Md.-National Capital Park and Planning Commission ID: Comprehensive Design Plan  
#CDP-0602, Hall Station Village Center  
Bowie Advisory Planning Board # 08-04 Date: January 31, 2008

**SUBJECT:** Comprehensive Design Plan #CDP-0602  
Hall Station Village Center  
MD Route 214 (Central Avenue) and Hall Road

**Subject:** Comprehensive Design Plan #CDP-0602  
Hall Station Village Center  
MD Route 214 (Central Avenue) and Hall Road

*Illustrative Concept for Decorative Wall along Hall Road*

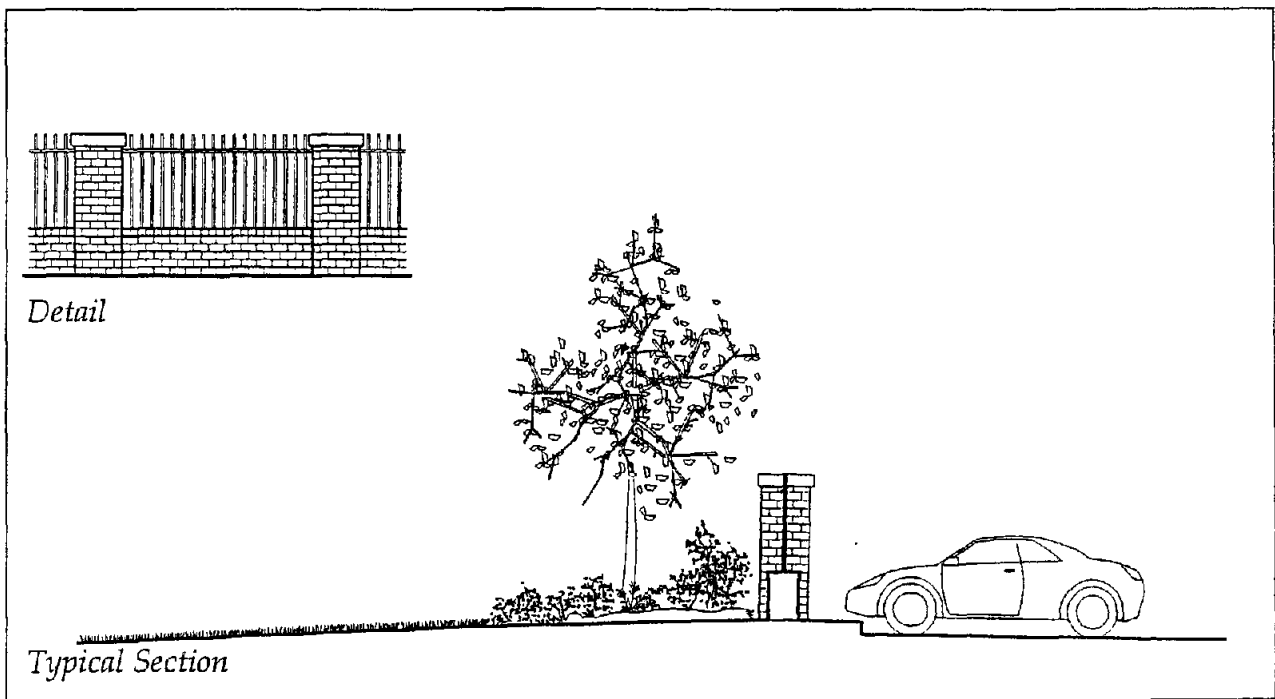
The streetscape proposed along Hall Road will include sidewalk, street trees and a six-foot high decorative screening wall. This wall is proposed to extend from the western end of Hall Road to the center vehicular access point. A pedestrian crosswalk should be provided at the Hall Road/Devonwood Drive intersection to provide a connection between the proposed project and the adjacent community. To provide screening and a sense of security to the proposed residential area, this decorative screen wall should be extended from the center access point to the eastern property line of the project. In addition, to create an upscale and aesthetically-pleasing impact along Hall Road, this entire frontage should be landscaped with street trees with a minimum caliper of four inches (4") at the time of planting, and spaced not more than 30 feet on center.

1. Condition #5 in Appendix A of the CDP text shall be amended to include the District Council’s language adopted in Zoning Ordinance #14-2007.
2. A pedestrian crosswalk shall be provided at the Hall Road/Devonwood Drive intersection.
3. The decorative screen wall proposed along the Hall Road frontage of the site shall be extended from the center vehicular access to the eastern property line of the project. The brick used to construct this decorative screening wall shall be identical to that used on other buildings throughout the project.
4. The entire site frontage along Hall Road shall be landscaped with street trees with a minimum caliper of four inches (4”) at the time of planting, and spaced not more than 30 feet on center.

*Illustrative Concept for Decorative Wall along Central Avenue*

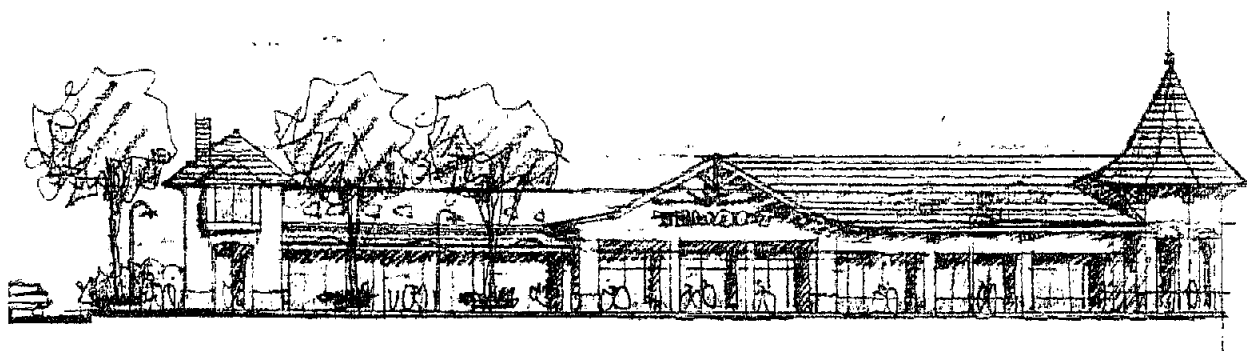
Views into the project should be minimized by the use of a combination of decorative walls, landscaping and berms. To prevent the appearance of a long, linear, continuous feature, such as the decorative wall proposed along MD Rt. 214, clusters of landscaping should be planted in front of the wall.

- C. Clusters of landscaping shall be planted in front of the decorative screening wall proposed along MD Rt. 214 for its entire length. The brick used for this decorative screening wall shall be identical to that used on other buildings throughout the project.

*Illustrative Concept for use of Stormwater  
Management Facility as an Amenity*

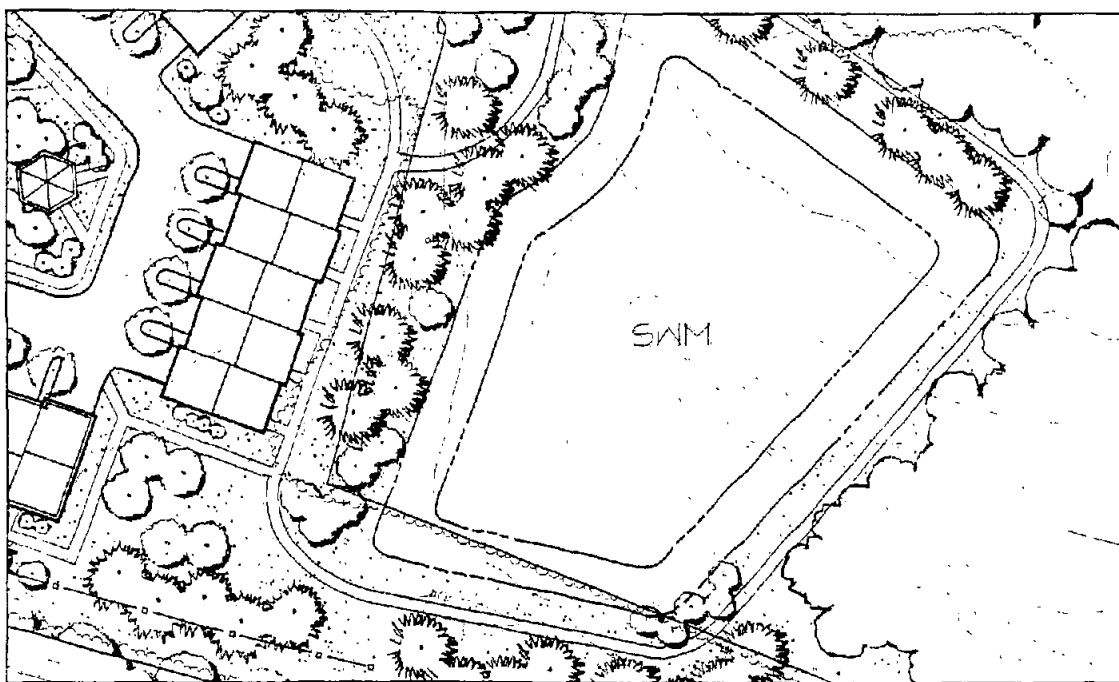
While no minimum width of the internal pedestrian system is proposed, in previous projects, the City has required that sidewalk be a minimum of six (6) feet in width in the non-residential areas. Since the pedestrian system in the residential area of the project proposes to link all residential buildings with each other, the tot lot and the stormwater management (SWM) pond, the minimum width of this portion of the pedestrian system should be eight (8) feet (Attachment 11).

6. Sidewalk in the non-residential areas shall be a minimum of six (6) feet in width. The minimum width of the pedestrian system in the residential area of the project that links all residential buildings with each other, the tot lot and the SWM pond, shall be eight (8) feet.
